# Memorandum

**SUBJECT: FILE NO. GP17-008. WINCHESTER BOULEVARD AND SANTANA ROW/VALLEY FAIR URBAN VILLAGE PLANS. ADOPTION OF THE WINCHESTER BOULEVARD AND SANTANA ROW/VALLEY FAIR URBAN VILLAGE PLANS PREPARED BY THE CITY AND THE COMMUNITY TO FURTHER THE URBAN VILLAGE MAJOR STRATEGY OF THE ENVISION SAN JOSE 2040 GENERAL PLAN.**

**REASON FOR THE SUPPLEMENTAL**

Figure 5-2: BUILDING HEIGHT DIAGRAM, Page 58

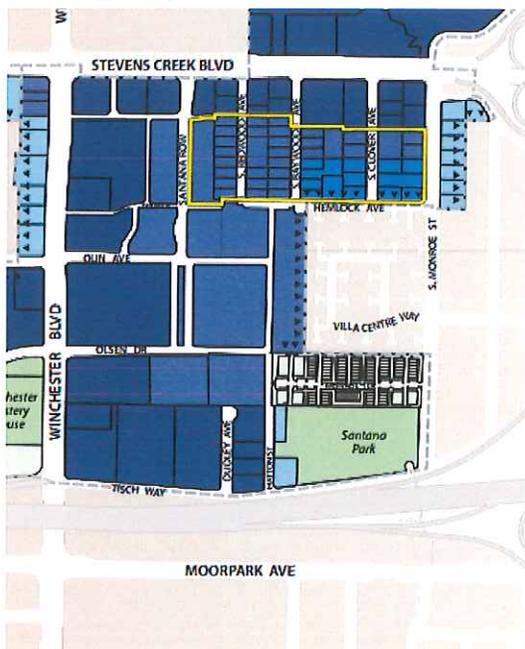
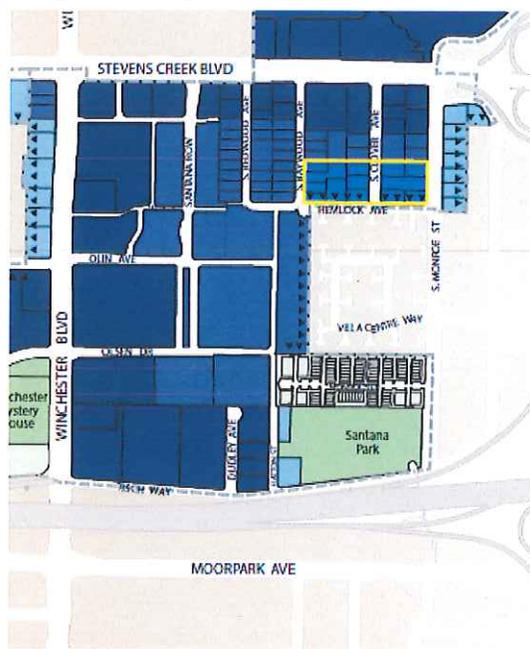
Revise the text and corresponding Height Diagram to only allow for sites that are one acre in size, and not 0.75 acres in size, to have a height limit beyond 65 feet specifically in the area Hemlock Avenue between South Baywood and Monroe Street as there are existing single-family detached homes located on the south side of Hemlock Avenue.

The area where this is applied is depicted on the Height Diagram with a yellow boundary line and is only for parcels north of Hemlock Avenue between South Baywood Avenue and South Monroe Street and not necessary for the larger area that is not located adjacent to single-family homes (See the height diagram below and attached).

In general, maximum height limits are “feathered down” from Winchester and Stevens Creek Boulevards toward the residential uses within and adjacent to the Village. In the area north of Hemlock Avenue between **Santana Row** **South Baywood** and Monroe Street, where parcels are typically small in size, a reduced height of 65 feet is applied on project sites less than **0.75 one** acre in size, in an effort to encourage lot consolidation and avoid large-scale buildings on small sites.
